## Report to the Committee of Adjustment Minor Variance Application Item S

**Date:** January 25, 2025  
**Address:** 176 May Avenue  
**Owner(s):** 1000882855 ONTARIO INC.  
**Applicant:** Shadi Arani, Arani Architecture  
**File Number(s):** MV-24 63  
**Related Application(s):** MV-24-62 and MV-24-64  
**Hearing Date:** January 30, 2025  
**Prepared By:** Francesco Caparelli, Planner I

## A0.01

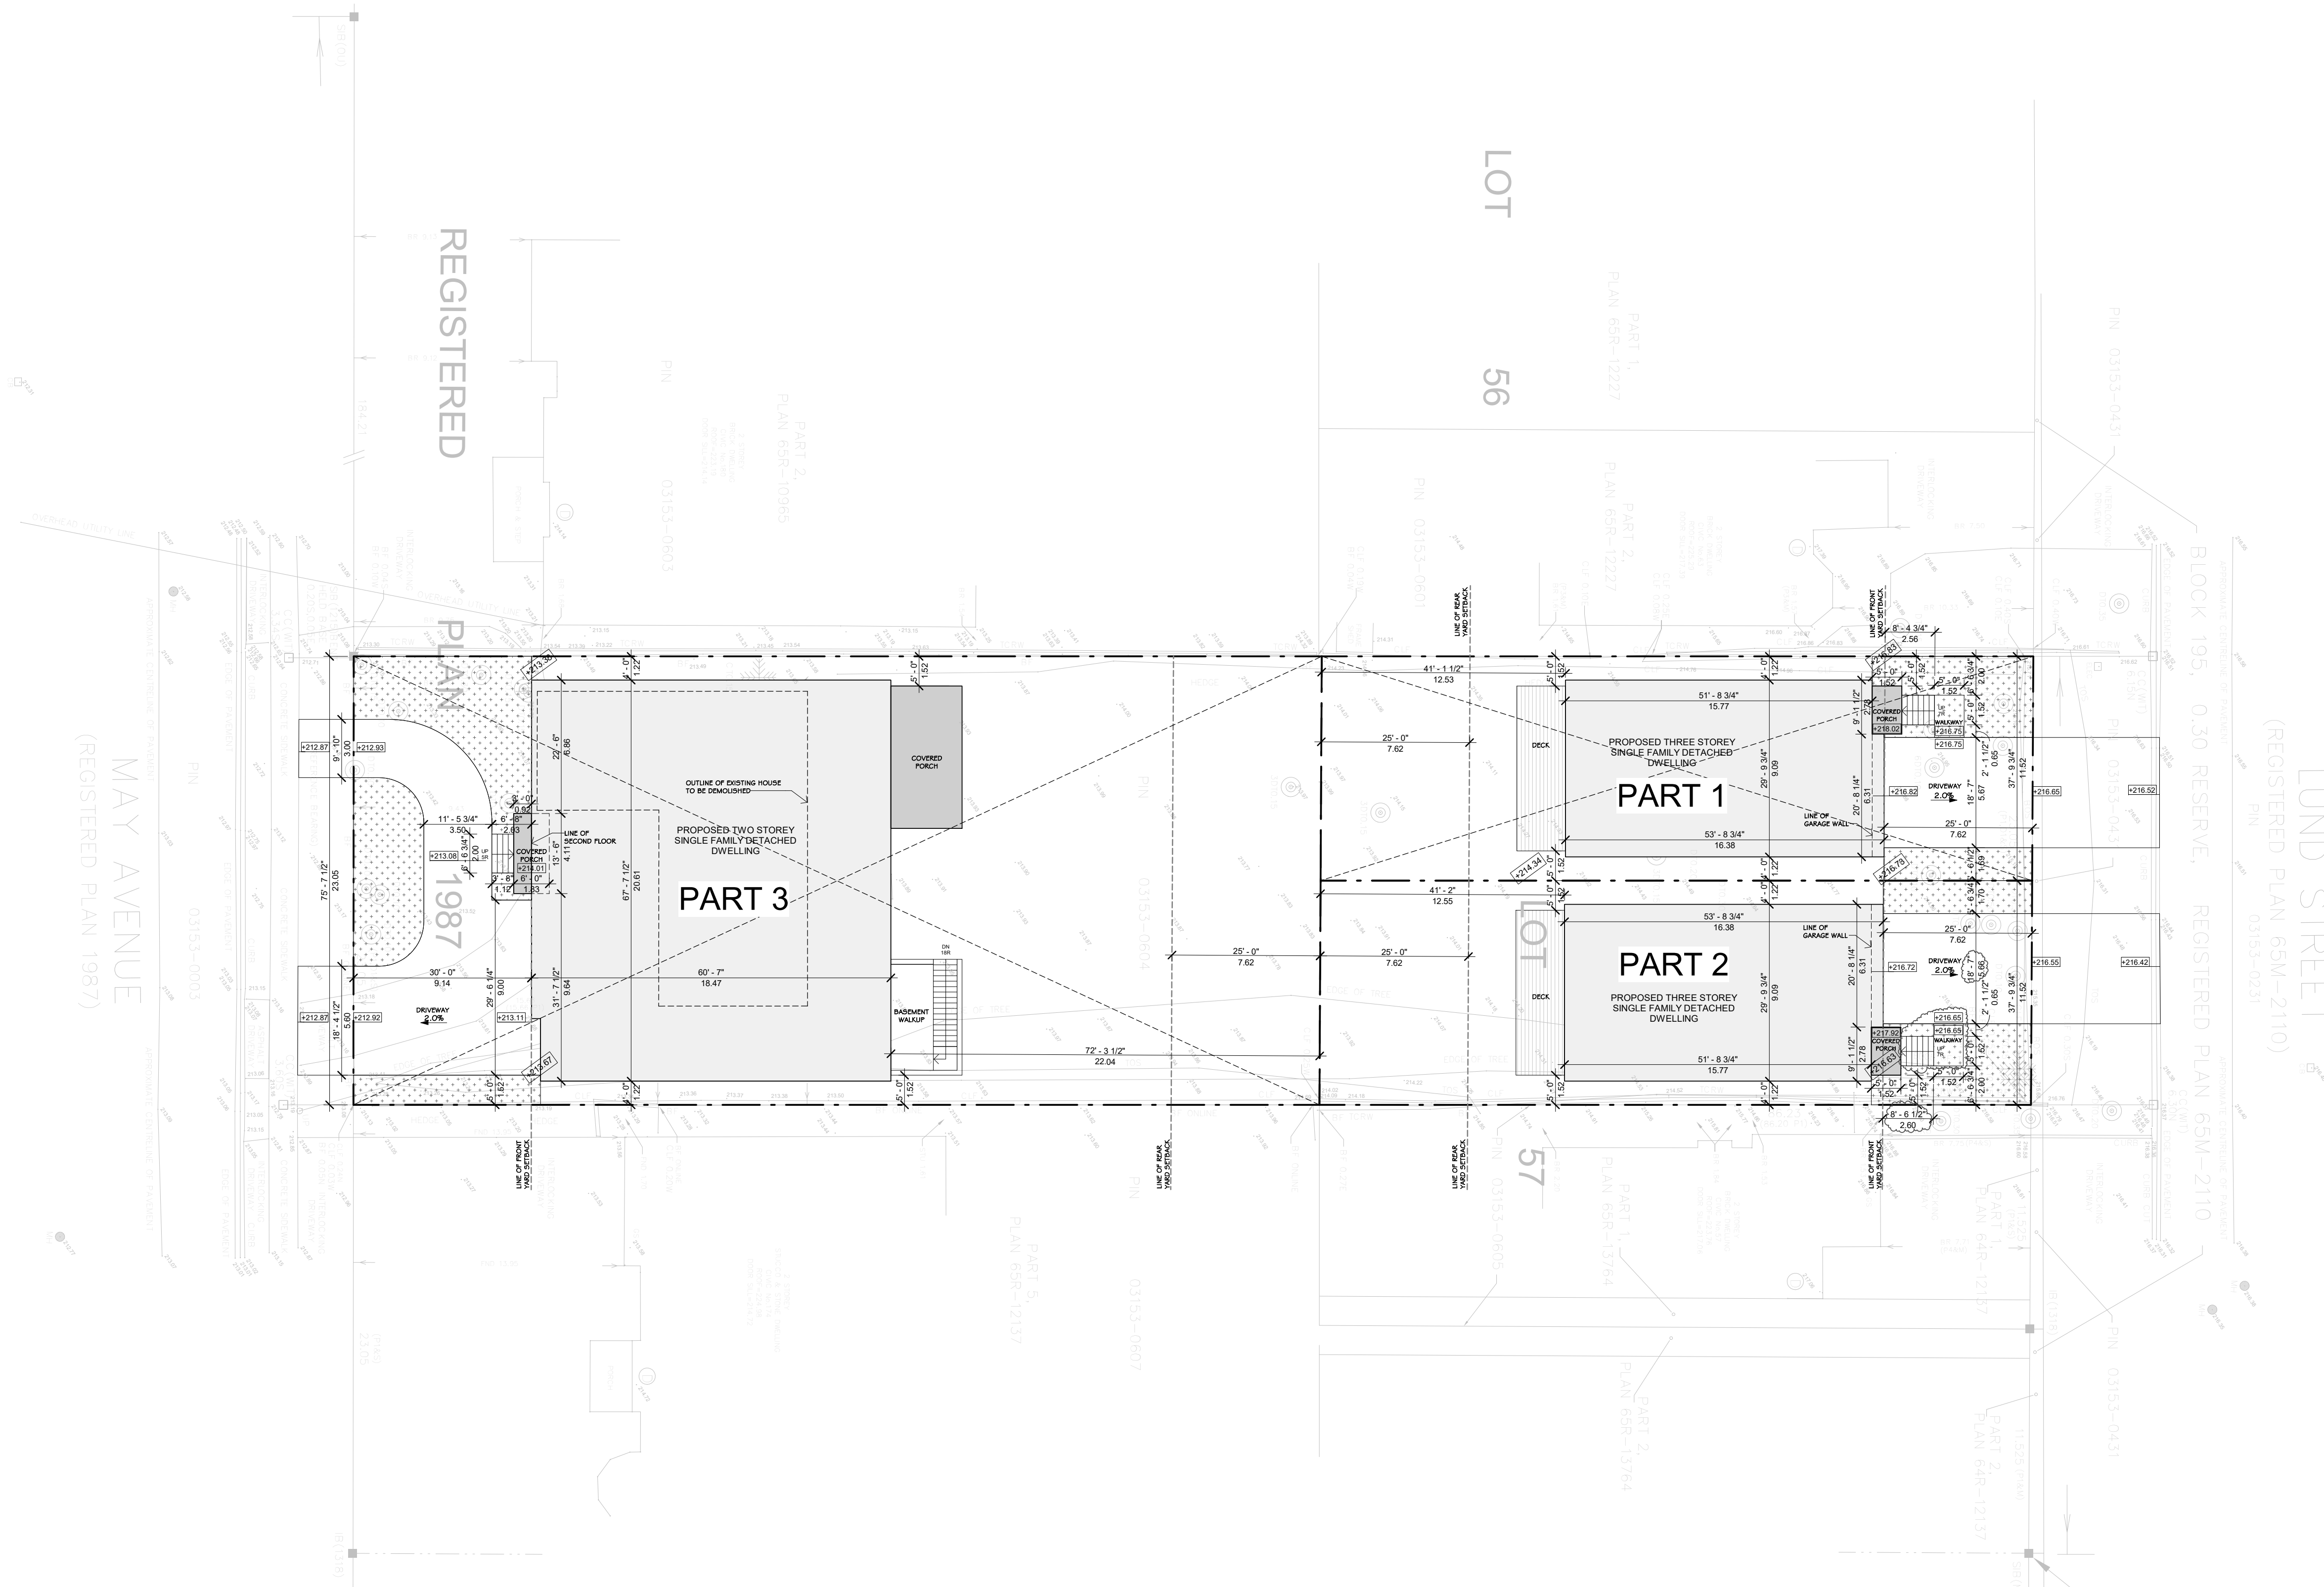
The intent of the Zoning By-law for maximum lot coverage is to control the maximum amount of building area that is permitted to cover the lot. The intent of the maximum encroachment into the front yard setback provision is to provide sufficient separation from the front yard lot line for maintenance purposes. The proposed front yard setback is not anticipated to adversely impact adjacent properties and the usability of the lands. The intent of the minimum side yard setback provision is to provide sufficient separation from the side yard lot line for lot drainage and maintenance purposes, in addition to addressing shadowing and overlook concerns. The proposed side yard setbacks are not anticipated to

adversely impact adjacent properties and the usability of the lands.

The construction of the proposed three-storey single-detached dwelling is compatible with and in keeping with the existing character of the neighbourhood, particularly with respect to building massing, scale and the patterns of existing yard setbacks.

In the opinion of staff, the proposed variances are considered minor in nature as the proposed three-storey single-detached dwelling will not adversely impact the neighbourhood. Furthermore, the proposed dwelling will not result in negative impacts to the streetscape or functionality of the subject lands and abutting properties.

Planning Staff have reviewed the requested variances pursuant to Section 45 (1) of the *Planning Act*, R.S.O, 1990, c.P.13, as amended, and are of the opinion that the requested variance(s) meet the four tests of the *Planning Act* for granting of minor variances. Staff recommend approval of the requested variance(s), subject to the conditions outlined in Appendix 'B'.

- 1) That the variances pertain only to the request as submitted with the application.
- 2) That development be substantially in accordance with the sketch submitted with the application as required by Ontario Regulation 200/96, as amended, Section 5.25.
